NDRE-Div T
Internal Report T-150
Ref: 84:T-134
SECRET
Copy no .14. of 50
June 1957

ELECTROMAGNETIC PROXIMITY FUZE FOR MORTAR SHELL
Supplement to final report on
contract N-02-MWP-A-54

Supplement to final report on
contract N-02-MWP-A-54

FIGURE 2.1 MODIFICATIONS IN GENERATOR-AMPLIFIER JOINT

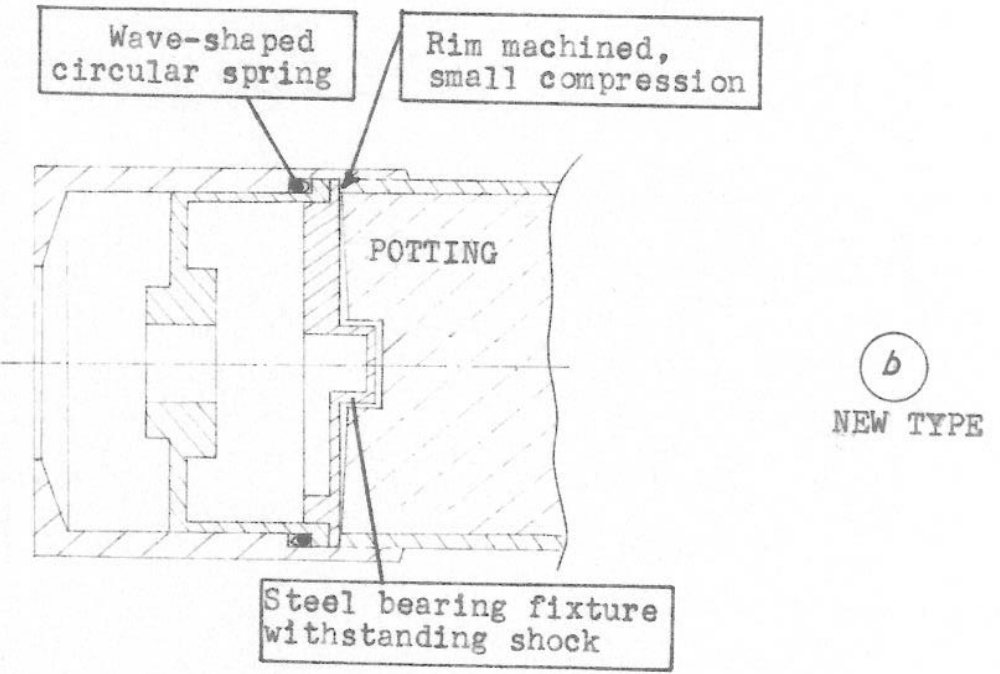
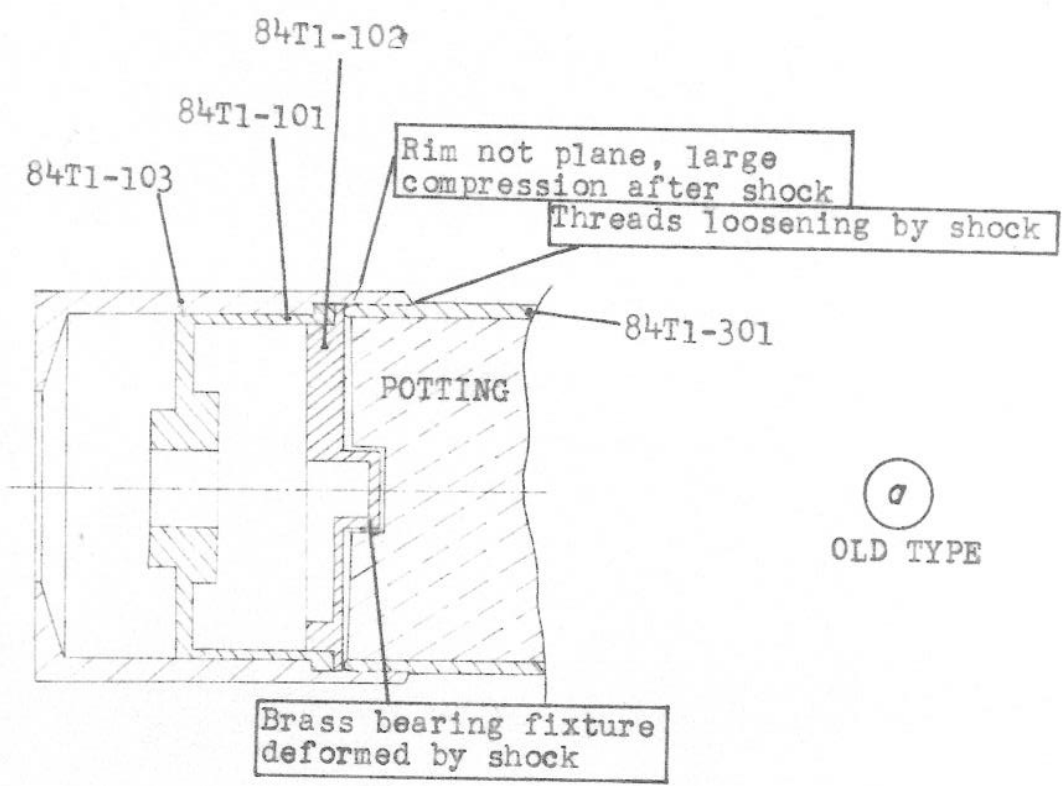
As may be noted from Figure 2.1 a, the generator in its housing rests directly on the thin rim of the amplifier housing. Tight connection is ensured by means of threads in the turbine housing. During shocks the compressive forces on the amplifier housing exceed the limit of elasticity of the Dural, which is very low, and as a consequence, the tightness of the threaded connection will decrease. This may bring about defective fuzes, due to faulty ground connection between units or broken lead wires. There were two possible ways to cure this deficiency, firstly to ensure that the top of the amplifier housing was absolutely plane, with no burrs whatsoever, secondly to make an arrangement whereby the permanent compression of the Dural could be tolerated, without the threaded connection loosening. Both methods are now being applied, as will be seen from Figure 2.1 b. Here a wavy steel spring is inserted between turbine housing and amplifier housing. The spring allows a compression of the Dural of about 0,5 mm, which is more than

sufficient. With the spring inserted during mounting, a torque of 1 kgm is applied to the turbine housing. After repeated shocks, this torque never reduces to less than 0,6 kgm, assuring a tight mechanical and electrical connection. Small modifications have therefore been introduced in:

Turbine housing, formerly dwg. 84T1-103, superseded by new 84T1-103S1,

Wavy steel spring, new drawing 84T1-115S1.

FIGURE 2.3 CRITICAL POINTS IN FUZE BASE CONSTRUCTION

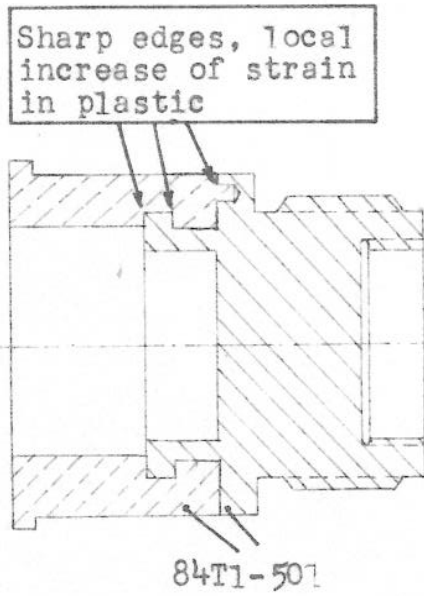
Shock-tests also revealed another constructional weak point, viz the polyethylene half of the base assembly, dwg. 84T1-501.

Cracks might occasionally occur here, these obviously were caused by too high stresses in the moulding due to sharp corner-effect. Figure 2.3 shows the critical points, and the obvious way of avoiding these is to round off the sharp edges.

FIGURE 2.4 CRITICAL POINT IN WORM WHEEL CONSTRUCTION

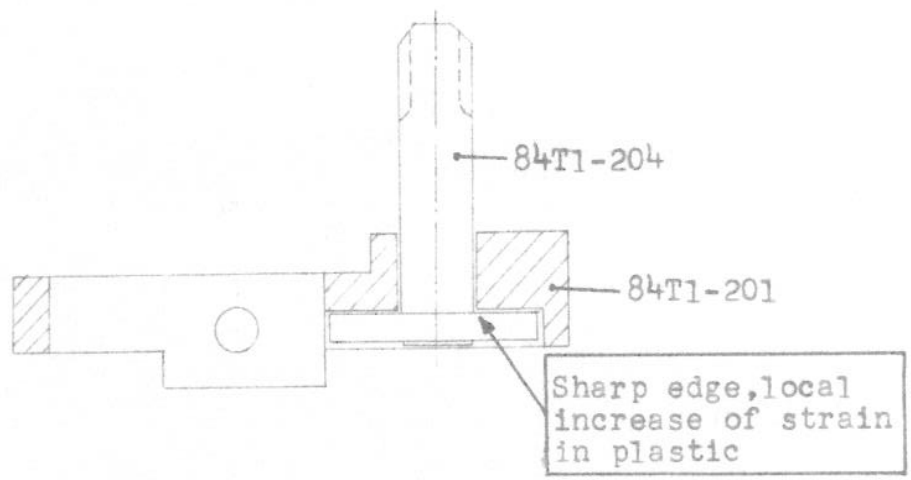
The worm wheel, dwg. 84T1-204, also showed a tendency to develop small cracks in the junction between wheel and stem. This was remedied by rounding off sharp edge (in mould) and affording sufficient clearance in the gear mounting plate, 84T1-201, Figure 2.4 shows a sketch of these critical points.

Material: Piano wire 0,8 mm		
ARMING SPRING	Scale	Drawn: C.H. 25.6.57
	~4:1	Traced: A.M.
		Ref:
NORWEGIAN DEFENCE RESEARCH ESTABLISMENT DIVISION T	Supersedes:	
	84T1-504S1	
	Superseded by:

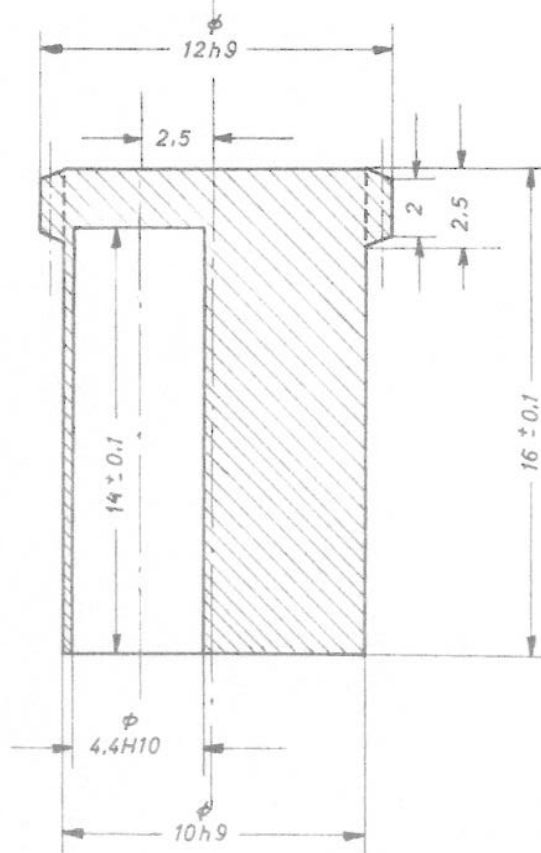
The arming spring, dwg. 84T1-504, has been slightly modified by pressing a short tubular rivet onto the smaller end of it, at the same time increasing the coil number. This assures a lower friction between arming rotor and spring, thereby avoiding some tendency for the sharp end of the steel wire to stick to the arming rotor, which is made of Dural.

<i>Material: Duraluminum</i>		
ARMING ROTOR	Scale	Drawn: W.H. 3.10.56
	4:1	Traced: Å.S.
	Ref:	
NORWEGIAN DEFENCE RESEARCH ESTABLISHMENT		Supersedes: 84T1-505
DIVISION T		84T1-505S1
		6 57
Superseded by:

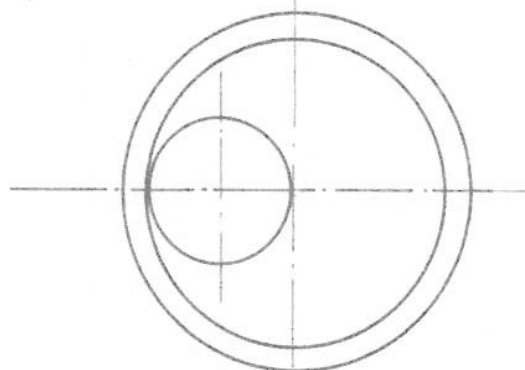
In the original detonator the contact between ring and tube was apt to be unstable after rough handling or storage at extremely varying temperatures. In the modified detonator (dwgs. 84T1-508S1 and -509S1) this tendency is avoided by making ring and tube in one piece. Another improvement is that the detonator pin previously made of brass, is now made of aluminum, due to the risk of hydrolysis of the lead azide whereby hydrazoic acid is formed which will react with copper alloys producing a sensitive salt. It will be noted that the total length of detonator has increased by 1 mm, consequently the bore depth in the arming rotor, dwg. 84T1-505, has to be increased from 13 to 14 mm.

GENERATOR BEARING FIXTURE

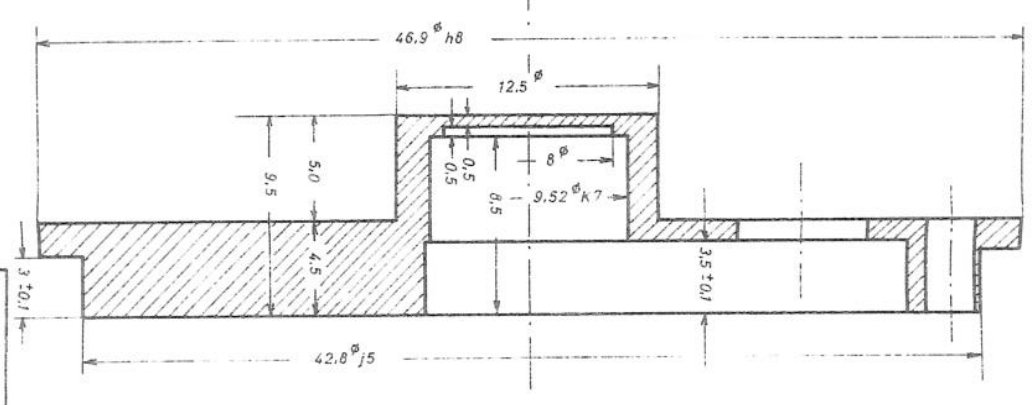
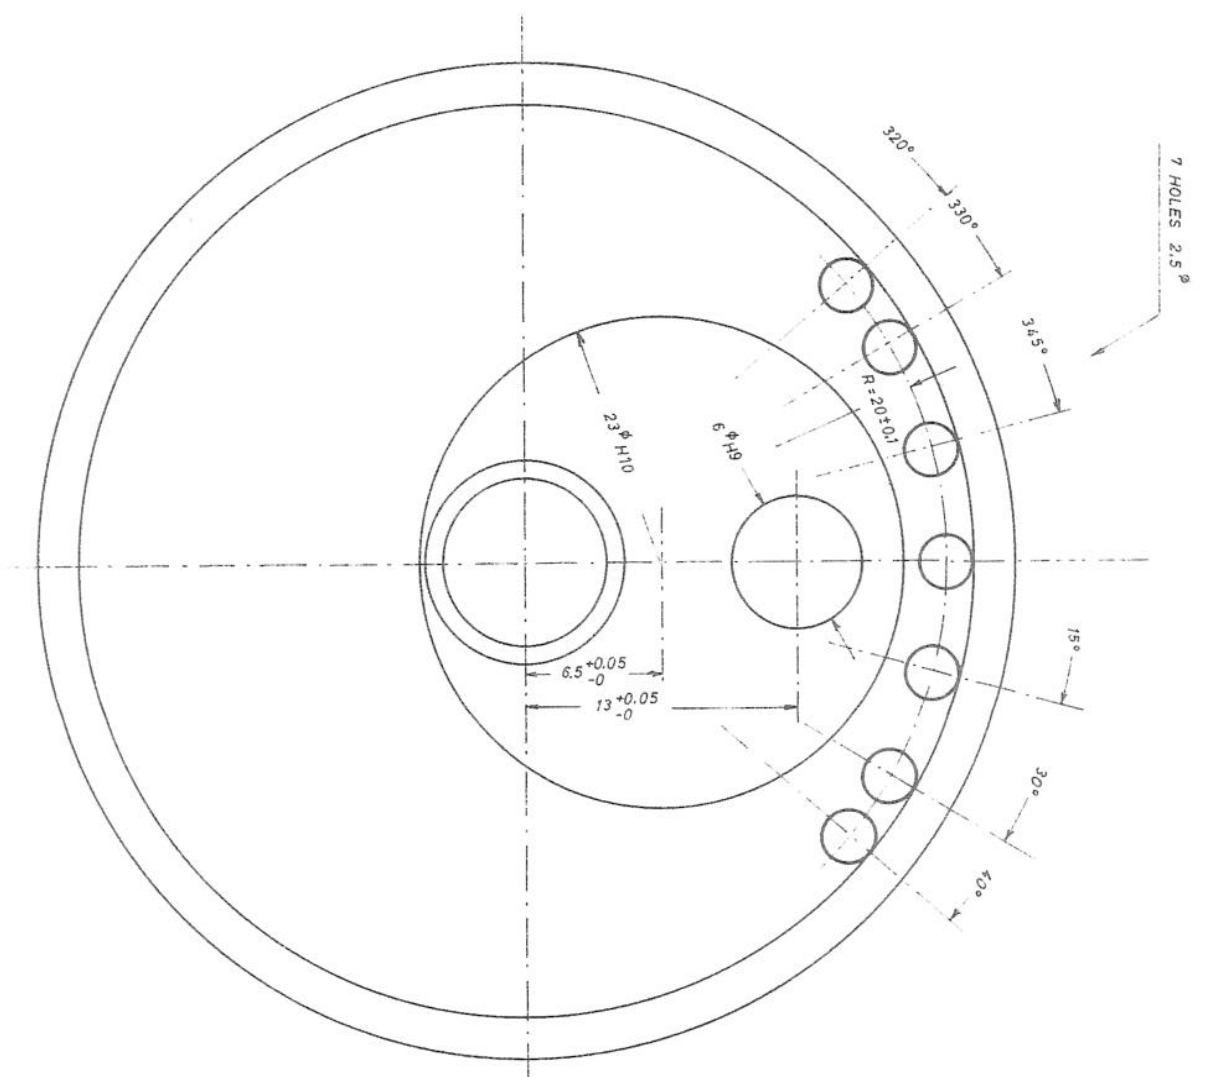
The bearing fixture, formerly dwg. 84T1-102, has been made of brass. Our reason for using brass was its easy machineability in small production, and no difficulties regarding material strength had previously been observed. However, the nylon gear mounting plate, 84T1-201, is a relatively new improvement, and has at a recent stage made a simpler production of the bearing fixture possible. Formerly, the gears were mounted directly into recesses in the brass bearing fixture. Owing to the nylon insert, the bearing fixture has been mechanically weakened, and consequently, during extended shock tests the central part of it bent permanently towards the back, into the amplifier. The forces acting on the fixture are only due to its own weight. This would have two dangerous consequences, firstly the risk of cracking the amplifier potting, secondly the risk of an eccentric or at least not coaxial roller bearing for the generator rotor shaft. Two methods were possible to eliminate these points, either to increase the dimensions of the bearing fixture or to change the type of material.

The latter method was used successfully, and steel was chosen instead of brass. No measurable deformation can then be seen after tens of shock tests at 10 000 g's.

1	Turbine	Material:	Injection Moulded Akulon
2	Insert	Material:	Brass
TURBINE		Scale	Drawn: 4.556 KHH+ES
		4:1	Traced: A.S.
NORWEGIAN DEFENCE RESEARCH ESTABLISHMENT		Ref:	
		Supersedes: 84T1-110	
DIVISION T		84T1-110S1	
		6.57	
		Superseded by:

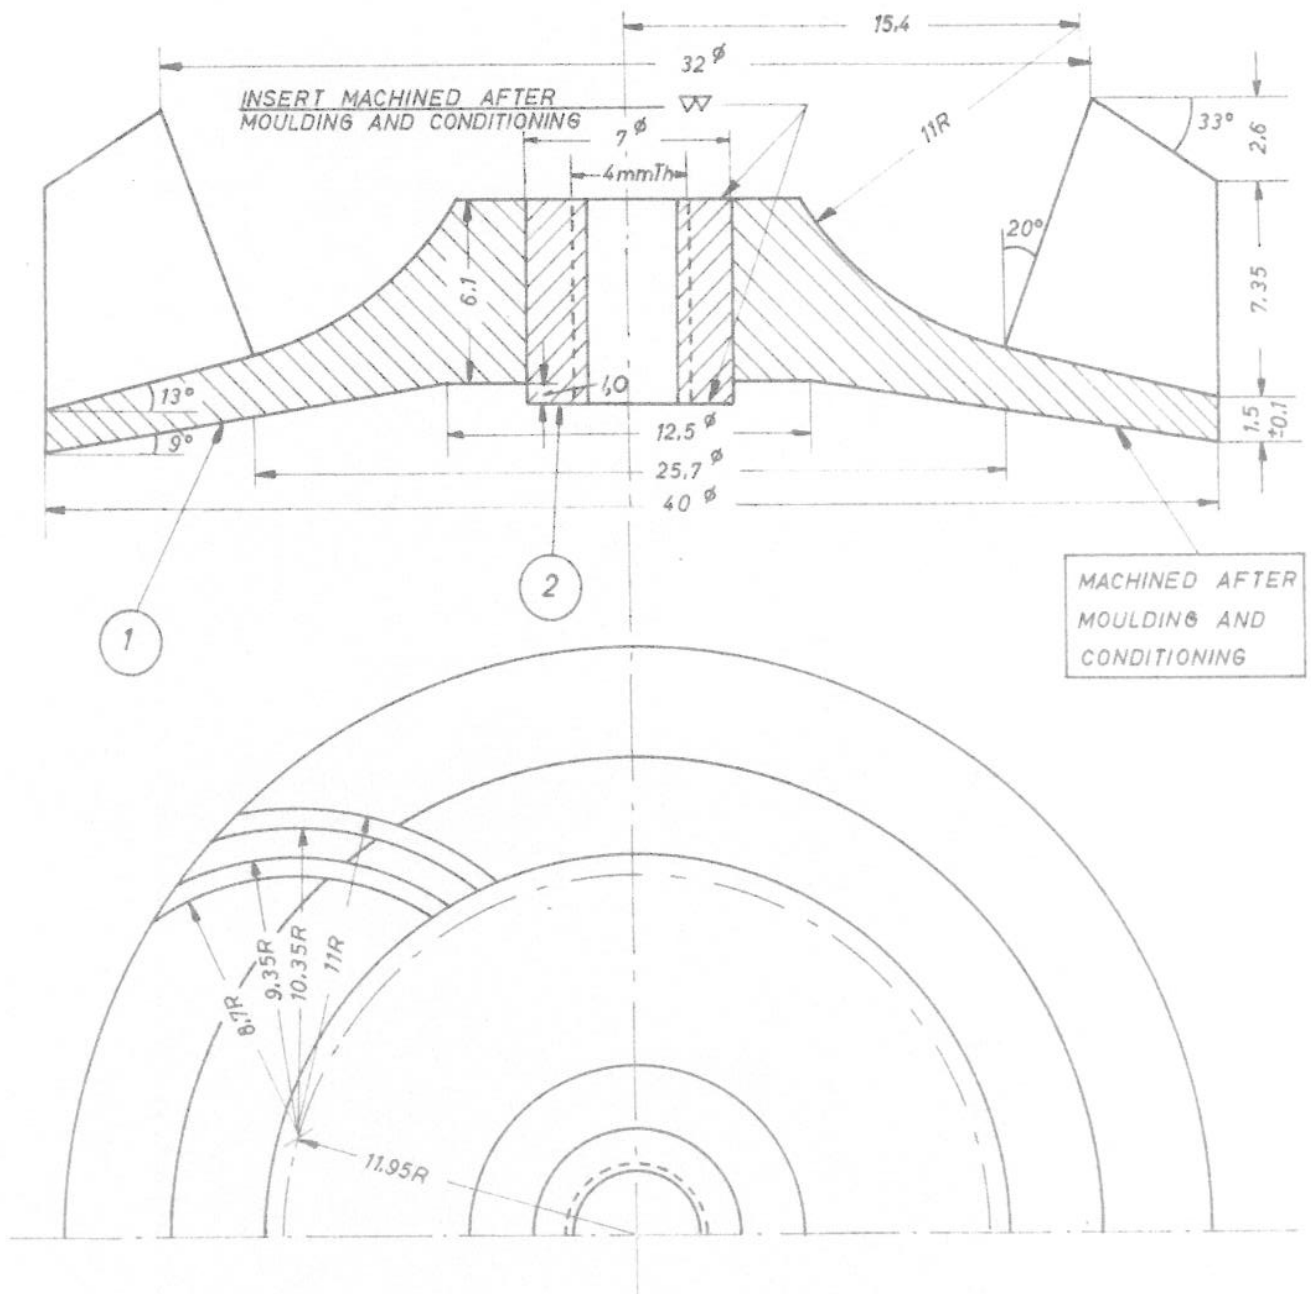
The protruding part of the turbine insert after machining, dwg. 84T1-110, has been increased by 0,4 mm to ensure an easier fit, as difficulties occurred during mounting due to the turbine rim touching the generator housing in some cases.
